City of Detroit
Inter-Departmental Communication

RE: Petition No. 1393
Request To Convert To Easements The East/West Alley In The Block Bound By
Marston, Woodward, MT. Vernon, And John R.

NOTICE OF PROPOSED CHANGE IN PROPERTY

B						<p>REQUEST TO CONVERT TO EASEMENT THE EAST/WEST PUBLIC ALLEY, 18 FT. WD. IN THE BLOCK BOUND BY MARSTON, WOODWARD, MT. VERNON AVE. AND JOHN R. ST.</p>	<p>CITY OF DETROIT CITY ENGINEERING DEPARTMENT SURVEY BUREAU</p>	
A					<p>JOB NO. 01-01</p>			
DESCRIPTION		DRWN	CHKD	APPD	DATE			<p>DRWG. NO. X 1393</p>
DRAWN BY		CHECKED						
DATE		APPROVED

PETITION NO. 1393
 CROSSROADS CONSULTING
 2020 14TH ST., SUITE 201
 DETROIT, MICHIGAN 48215
 C/O TONJA STAPLETON
 PHONE NO. 313 338-3772

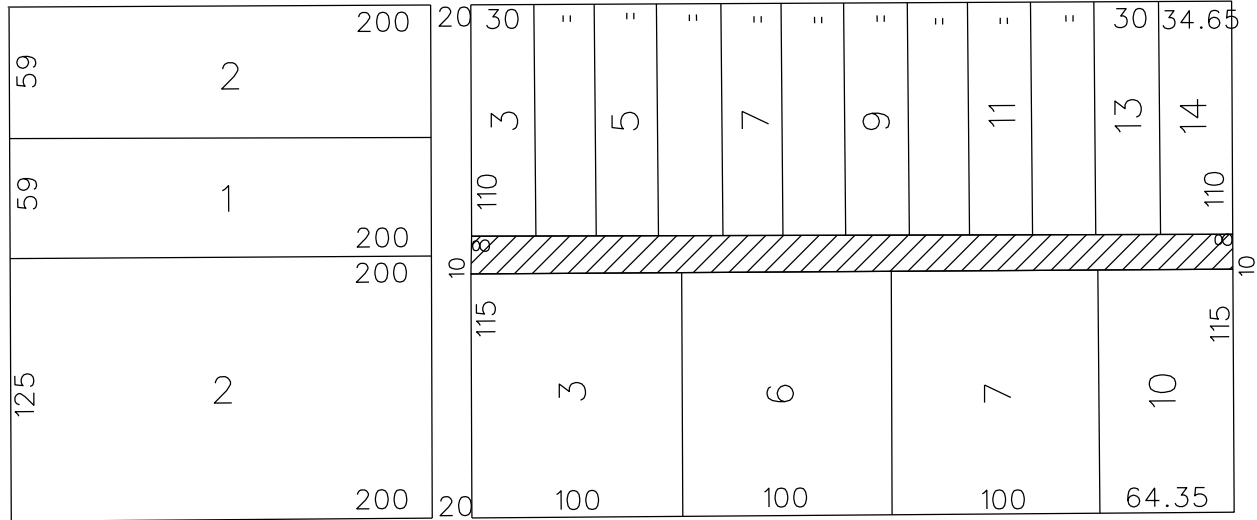
- Our records indicate that there is a sewers in the requested easement. DWSD has no objections to the requested conversion to easement provided that the attached Provisions for Conversion to Easement are strictly followed.

1. An easement, the full width of the existing right of way, is reserved for the Detroit Water and Sewerage Department for the purpose of installing, maintaining, repairing, removing, or replacing any sewers, water mains, fire hydrants and appurtenances, with the right of ingress and egress at any time to, and over said easement for the purpose above set forth.

2. Said owners of the adjoining property, for themselves, their heirs and assigns, agree that no building or structure of any nature whatsoever, including fences, porches, patios, balconies, etc., shall be built upon or over said easement, or that no grade changes or storage of materials shall be made within said easement without prior written approval and agreement with the Detroit Water and Sewerage Department.
